## Product Change Notification / CADA-20GQNA115

CCB 4827 Final Notice: Qualification of MTAI as a new assembly site for selected LAN925xx and LAN9353 device families available in 64L QFN (9x9x0.9mm) package.

**CCB 4827**  
**Pre and Post Change Summary**  
**PCN #: CADA-20GQNA115**

ASE

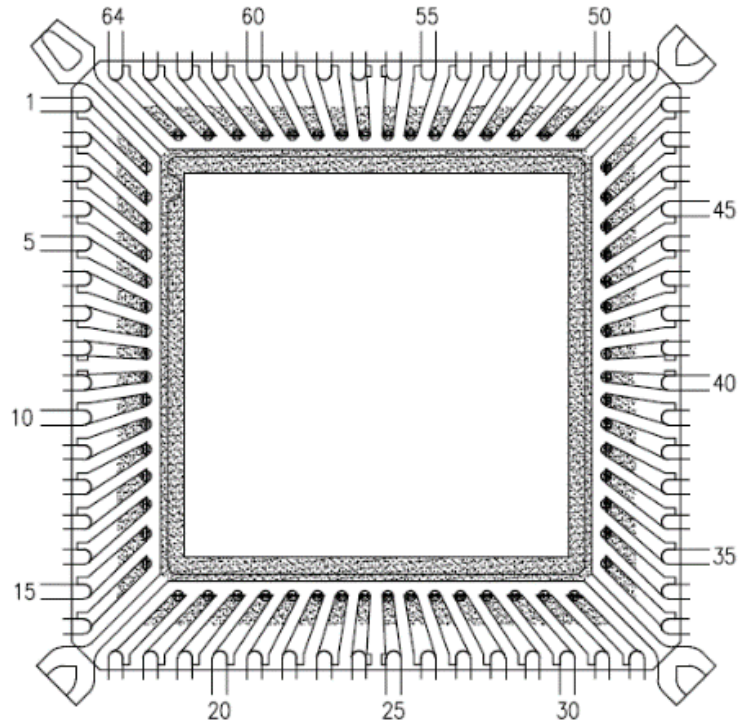
Lead frame Paddle Size

287x287mils

MTAI

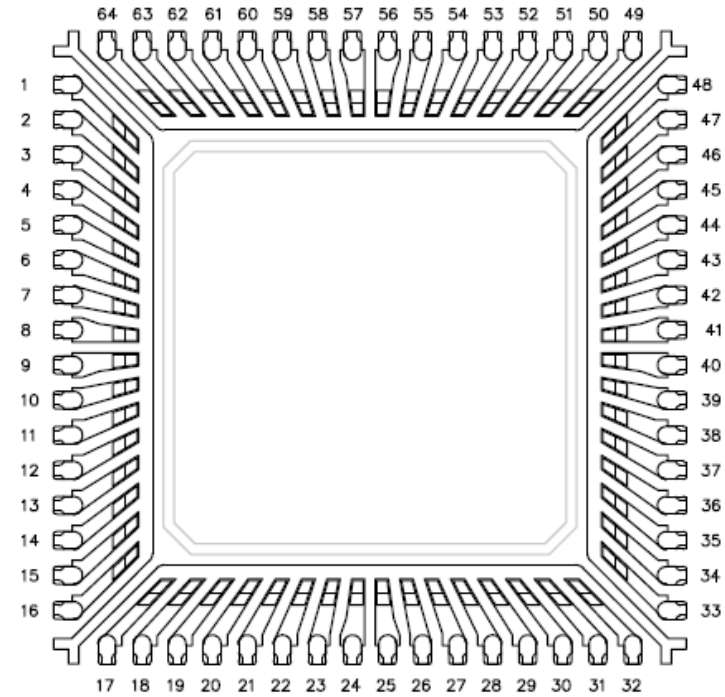
Lead frame Paddle Size

244 x 244mils
